**Re: GE-Pittsfield/Housatonic River Site  
Lyman Street Area (GECD430) – Properties East of Lyman Street  
EPA Requested Information and Analytical Data for Proposed Backfill Sources**

LYMAN STREET AREA REMEDIAL ACTION

# REVISED ENGINEERED BARRIER

## FINAL GRADE PLAN

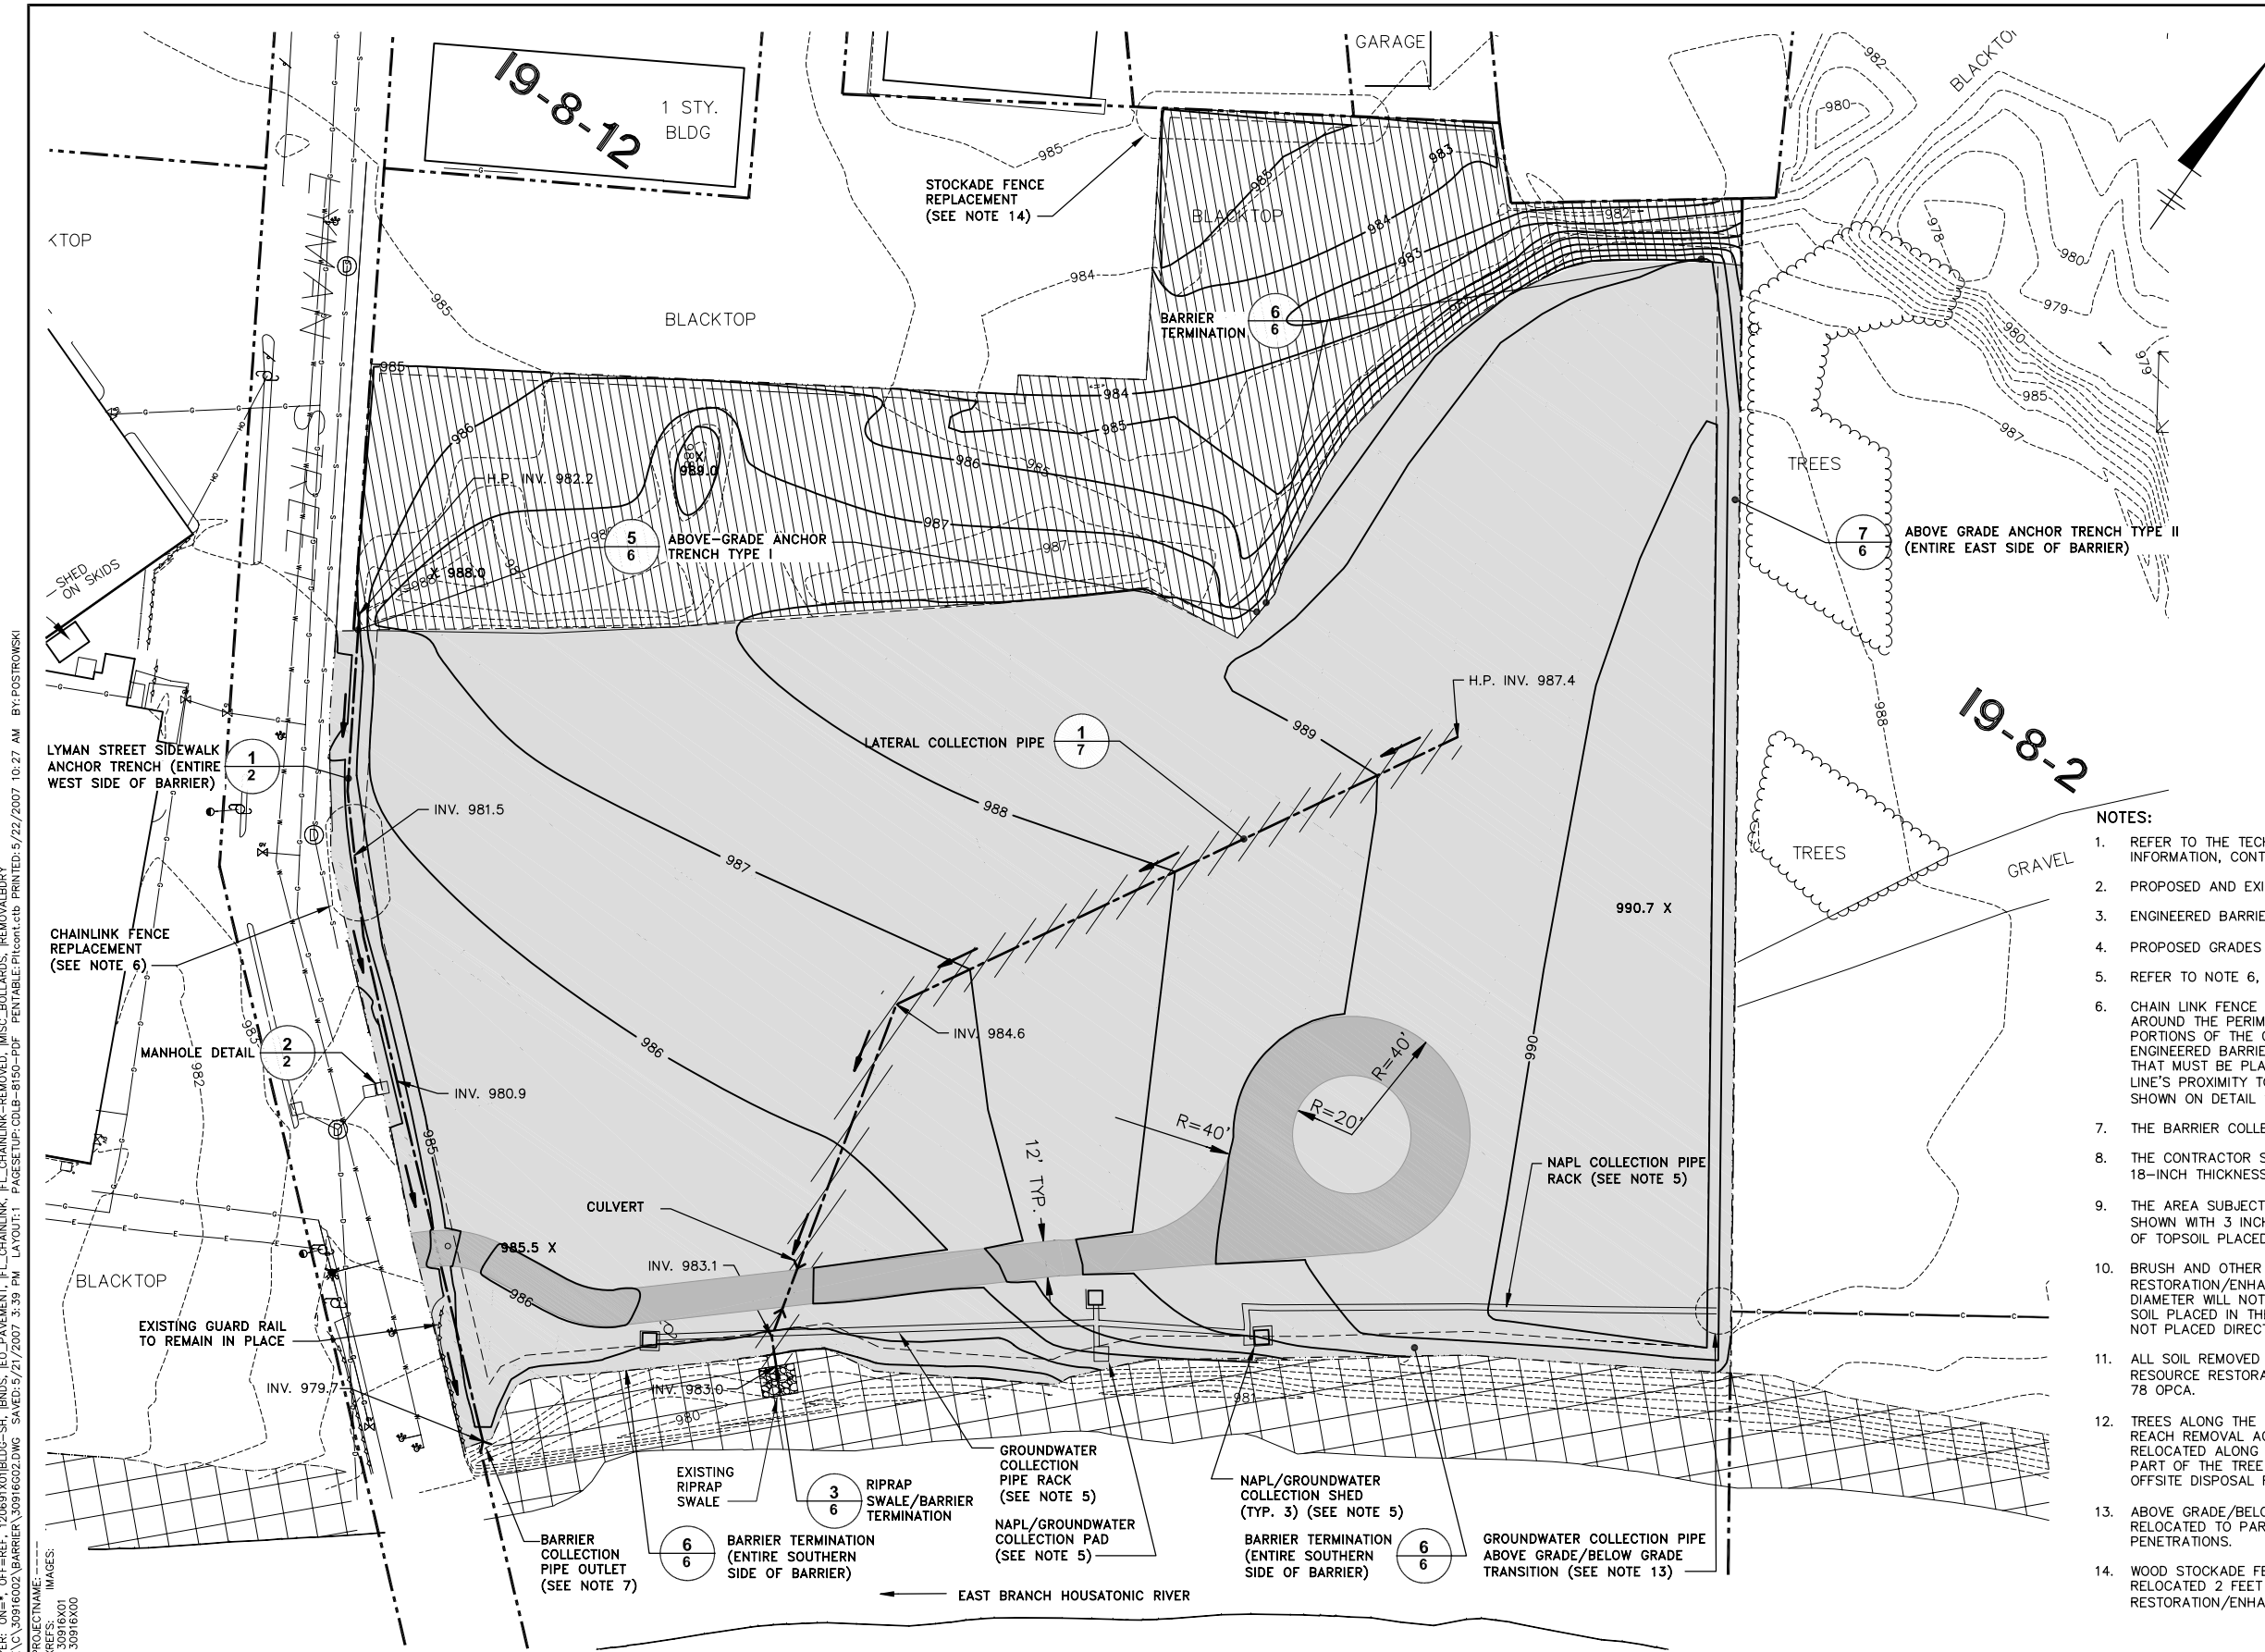
The attached Revised Engineered Barrier Final Grade Plan (Attachment 1) addresses the following construction activities:

- extending the engineered barrier to the existing pavement along Lyman Street;
- replacing the chainlink fence along Lyman Street within the engineered barrier;

- relocating trees along the riverbank that are removed as a result of the engineered barrier installation;
- removing brush and trees smaller than six inches in diameter in the area subject to Natural Resource Restoration/Enhancement;

- disposing of soil that is removed as part of grading activities in the area subject to Natural Resource Restoration/Enhancement as non-TSCA material at the Hill 78 On-Plant Consolidation Area (OPCA);

- placing three inches of topsoil over soil fill in the area subject to Natural Resource Restoration/Enhancement;
- relocating the above grade/below grade transition of the groundwater collection pipe outside of the engineered barrier; and

- relocating the fence along the northern limit of Parcel I9-8-1 to the property line.

9. THE AREA SUBJECT TO NATURAL RESOURCE RESTORATION/ENHANCEMENT SHALL BE GRADED AS SHOWN WITH 3 INCHES (MINIMUM) OF TOPSOIL PLACED ABOVE IMPORTED SOIL FILL OR 3 INCHES OF TOPSOIL PLACED ABOVE EXISTING/EXCAVATED SURFACE.

10. BRUSH AND OTHER GROUND VEGETATION WITHIN THE AREA SUBJECT TO NATURAL RESOURCE RESTORATION/ENHANCEMENT SHALL BE REMOVED. ALL TREES LARGER THAN SIX INCHES IN DIAMETER WILL NOT BE REMOVED AND SHALL BE PROTECTED FROM DAMAGE AND DISTURBANCE. SOIL PLACED IN THE VICINITY OF THE TREES TO REMAIN SHALL BE FEATHERED SO THAT SOIL IS NOT PLACED DIRECTLY AROUND THE TRUNK OF THE TREE.

11. ALL SOIL REMOVED AS PART OF REGRADING ACTIVITIES IN THE AREA SUBJECT TO NATURAL RESOURCE RESTORATION/ENHANCEMENT SHALL BE DISPOSED OF AS NON-TSCA SOIL AT THE HILL 78 OPCA.

12. TREES ALONG THE RIVERBANK WITHIN THE AREA PREVIOUSLY ADDRESSED AS PART OF 1/2 MILE REACH REMOVAL ACTIVITIES THAT ARE WITHIN THE ENGINEERED BARRIER LIMITS MUST BE RELOCATED ALONG THE RIVERBANK IN LOCATIONS DETERMINED BY GE. ALL SOIL REMOVED AS PART OF THE TREE RELOCATION ACTIVITIES SHALL BE DISPOSED OF AS TSCA SOIL AT AN OFFSITE DISPOSAL FACILITY.

13. ABOVE GRADE/BELOW GRADE TRANSITION OF THE GROUNDWATER COLLECTION PIPE SHALL BE RELOCATED TO PARCEL 19-8-2, JUST OUTSIDE OF THE ENGINEERED BARRIER, TO AVOID LINER PENETRATIONS.

14. WOOD STOCKADE FENCE THAT EXISTS 2 FEET SOUTH OF THE PROPERTY LINE SHALL BE RELOCATED 2 FEET NORTH TO THE PROPERTY LINE TO FACILITATE NATURAL RESOURCE RESTORATION/ENHANCEMENT ACTIVITIES.
